## 5.1. MATERIAL CHANGE OF USE FOR A MIXED DEVELOPMENT AT 49 MACROSSAN STREET, PORT DOUGLAS

<b>REPORT AUTHOR(S)</b>	Jenny Elphinstone, Senior Planning Officer
<b>GENERAL MANAGER</b>	Nick Wellwood, General Manager Operations
<b>DEPARTMENT</b>	Development Assessment and Coordination
<b>PROPOSAL</b>	Combined Application - MCU Impact/Code (mixed use development - restaurant, retail, multi-unit housing & holiday accommodation)
<b>APPLICANT</b>	W B Petrie & L H Petrie C/- Planz Town Planning PO Box 181 EDGE HILL QLD 4870
<b>LOCATION OF SITE</b>	49 Macrossan Street, Port Douglas
<b>PROPERTY</b>	Lot 410 on PTD2091

### RECOMMENDATION

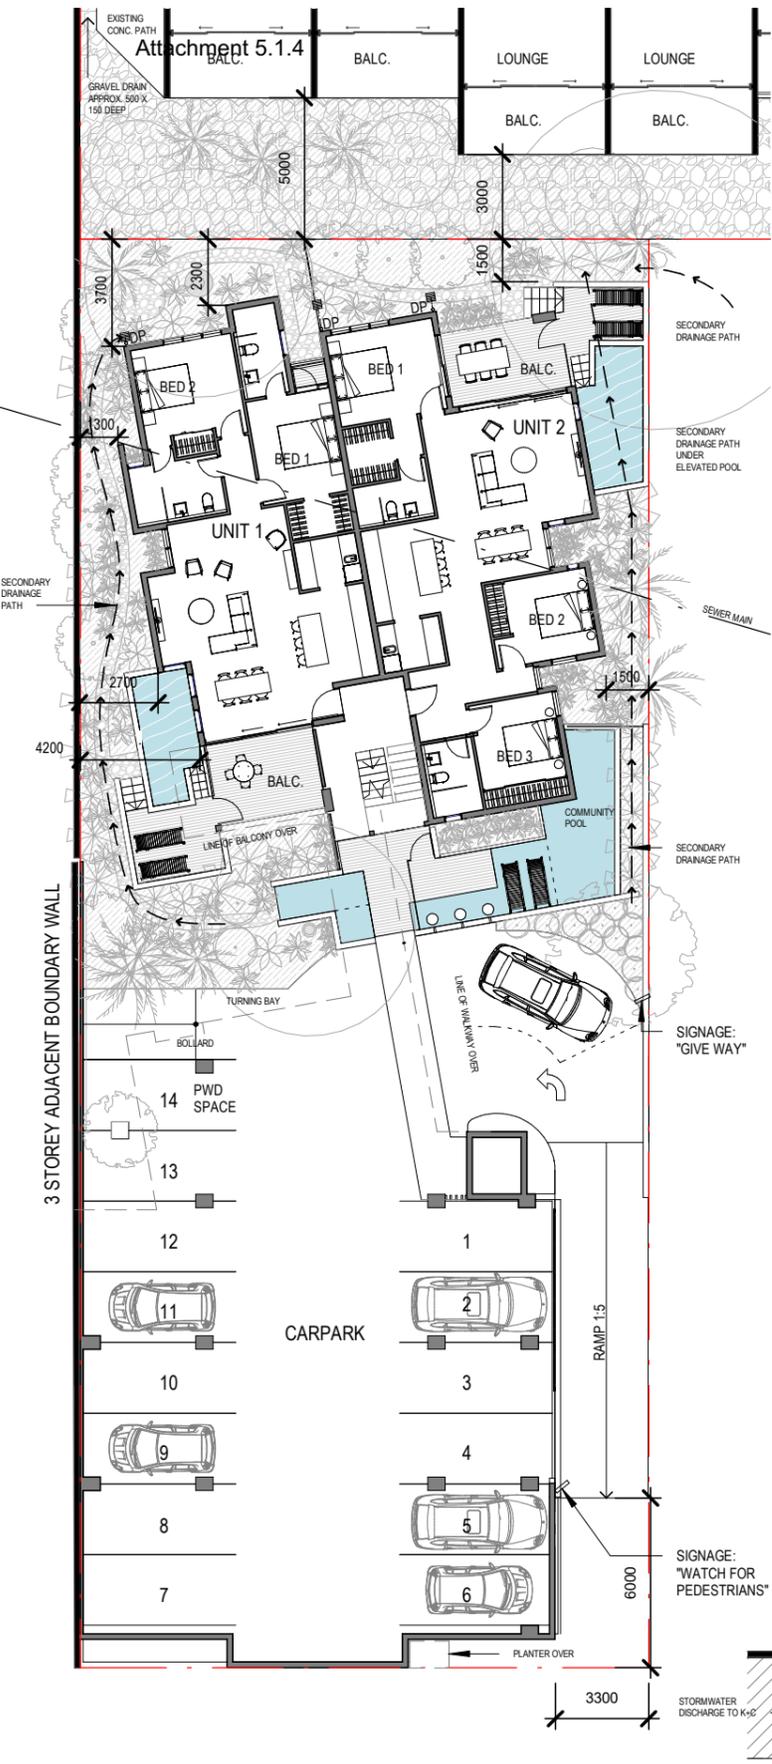
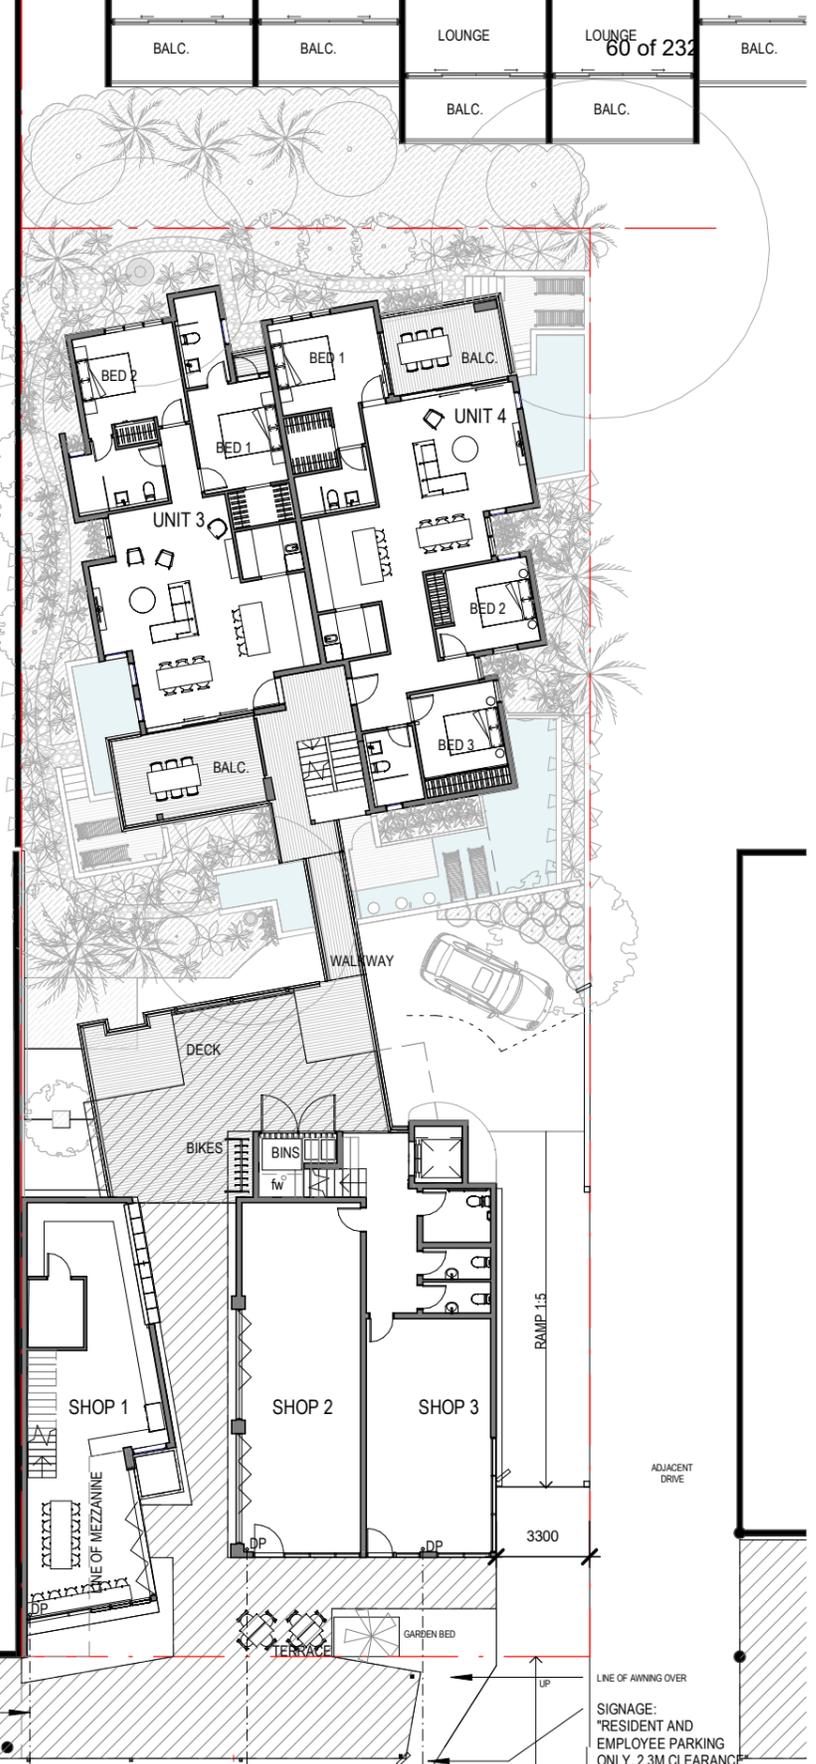
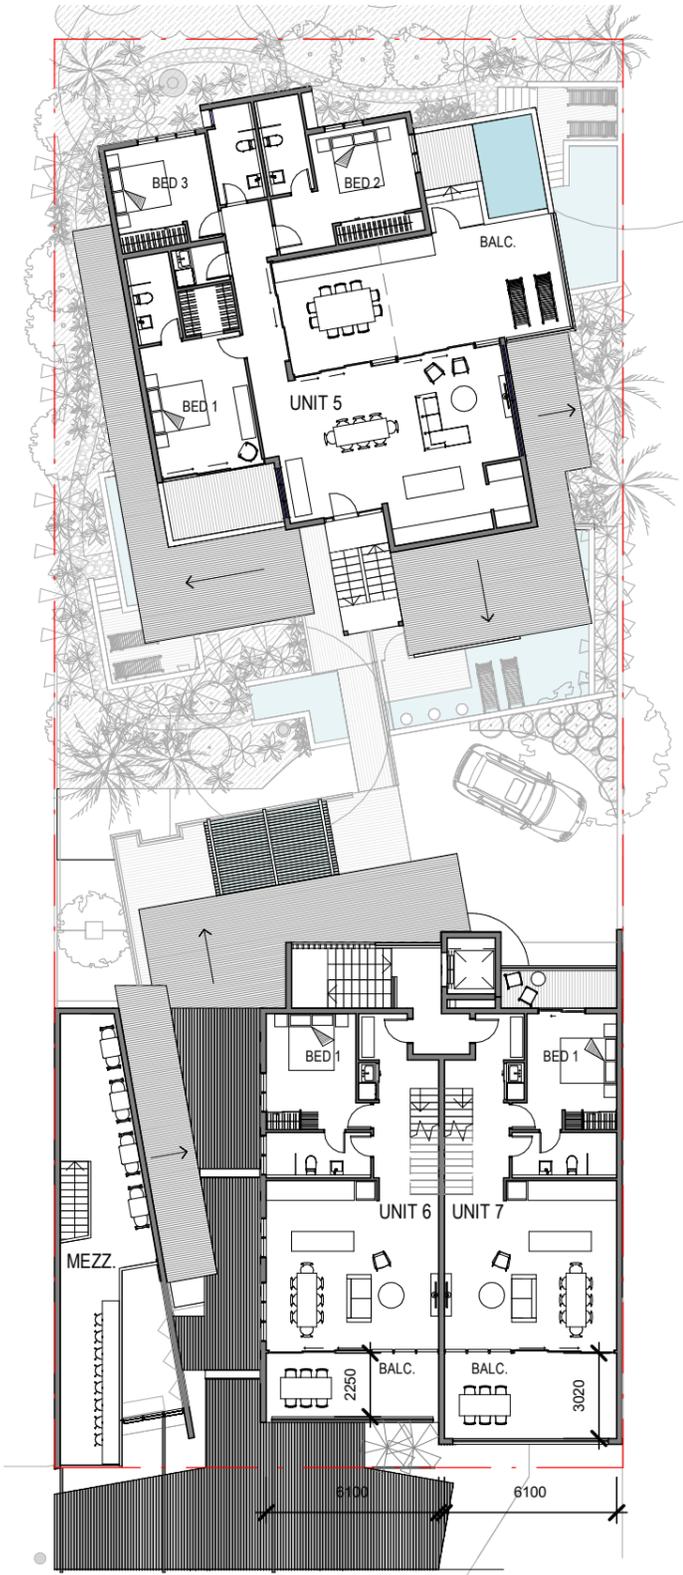
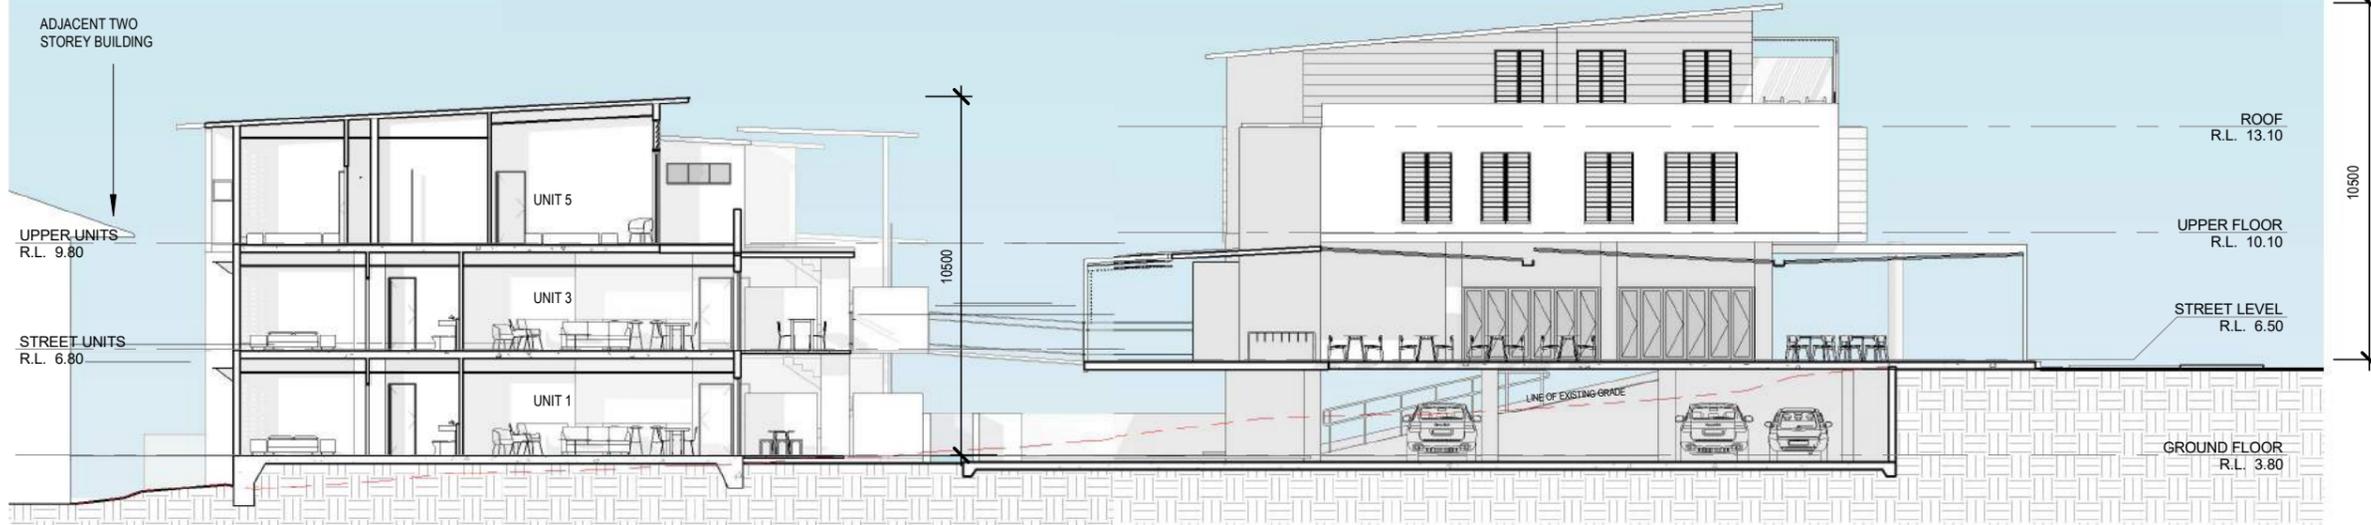
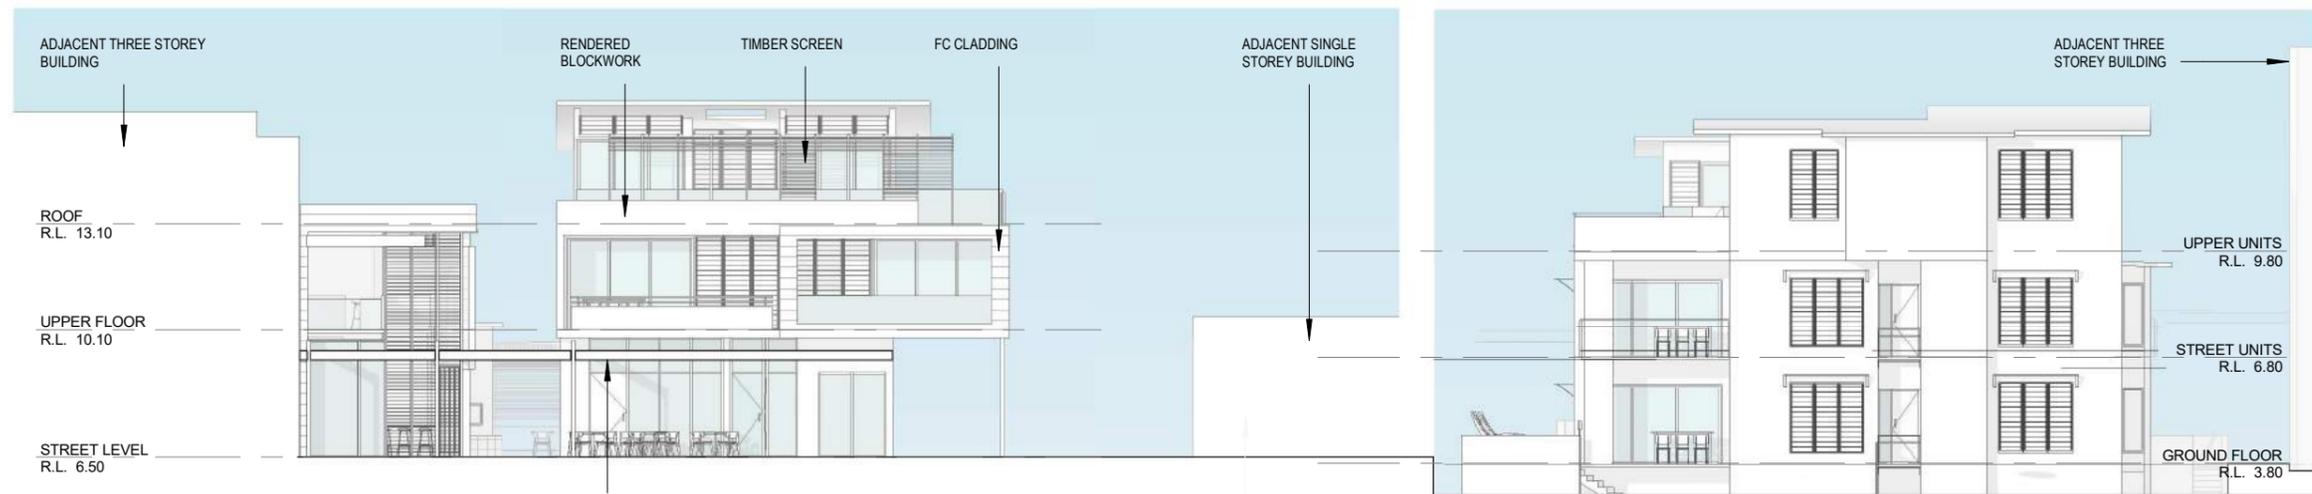
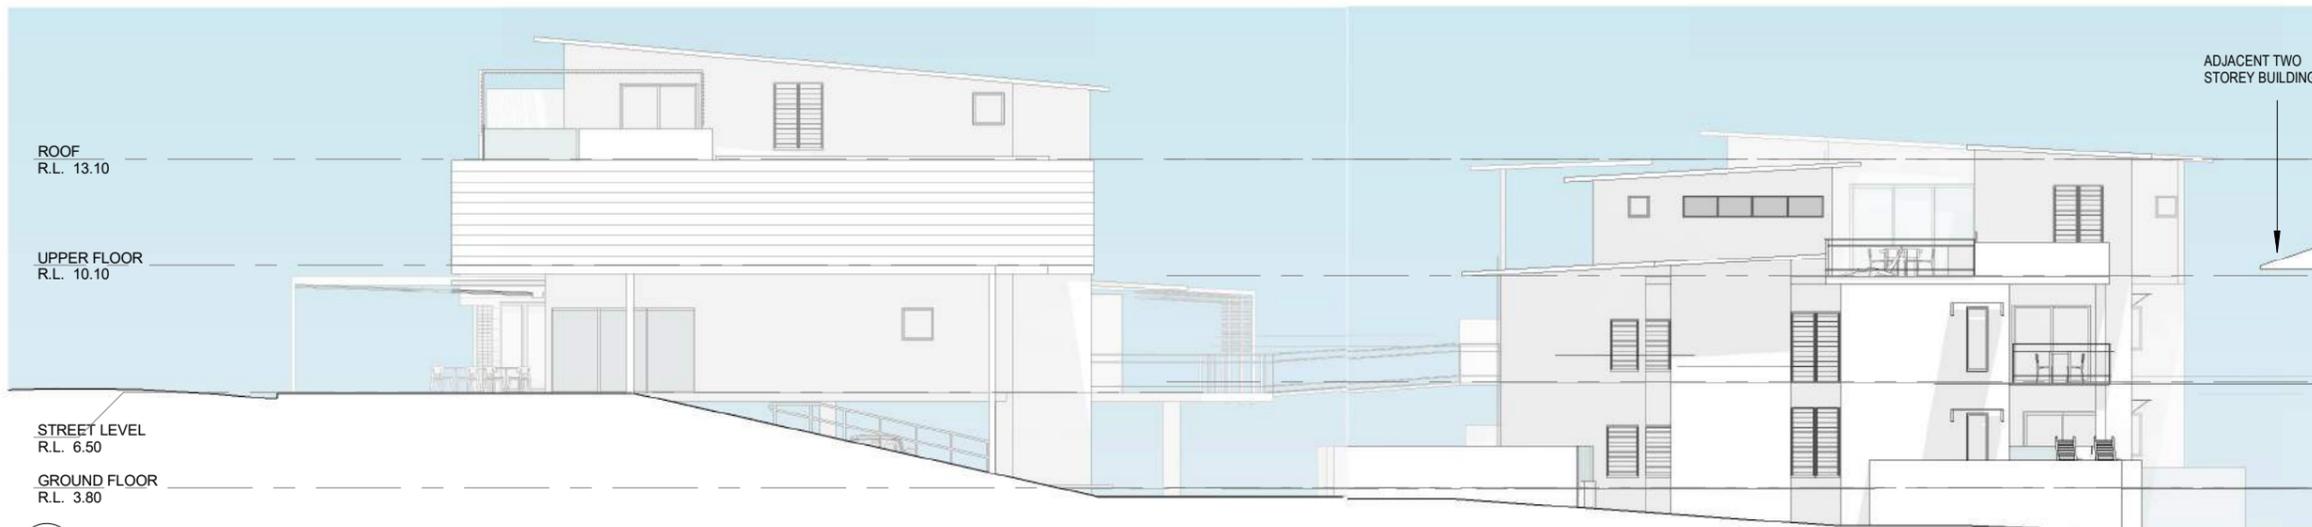
Concern was raised with the limited extent of covered awning to the public sidewalk. In response the applicant has provided, subsequent to the public notification stage, plans responding to design issues and this includes an extended awning, a disabled driver car park and signage to the basement car park. This amended floor plan and elevation is included in Attachment 4.

Benchmark reference	Reasons for the approval or approval subject to conditions despite non-compliance with any of the benchmark.
<b>A3.1 of Commercial Planning Area Code required a street awning to the whole of the street frontage.</b>	conditions require an amended design and the Advice notes the submitted “amended plan.”
Loading Area <b>A5.3 of the Commercial Planning Area Code requires loading areas to be suitably screened, implying these are provided on the land.</b>	No onsite loading facilities are provided on the land and given the basement parking this would be unreasonable. The applicant has indicated a willingness to construct parking and a limited size loading parking space on the adjacent street. The Department of Transport and Main Roads advised that the design is suitable. The design complies with the Performance Criteria.
Road Frontage <b>A1.1 of the Multi-unit Housing and Holiday Accommodation Code has an acceptable outcome requiring a minimum road frontage of 20m.</b>	No concern is raised with the 20m road frontage of the property as the applicant has demonstrated through the design that the land can satisfactorily accommodate the building, parking and open space. The design meets the Performance Criteria.

5. The Applicant's amended drawing prepared by TPG Architects, WLP-01, DA-100J, dated 7 March 2018, satisfactorily meets the amended design requirements as listed under Condition 3 parts a, b and h.
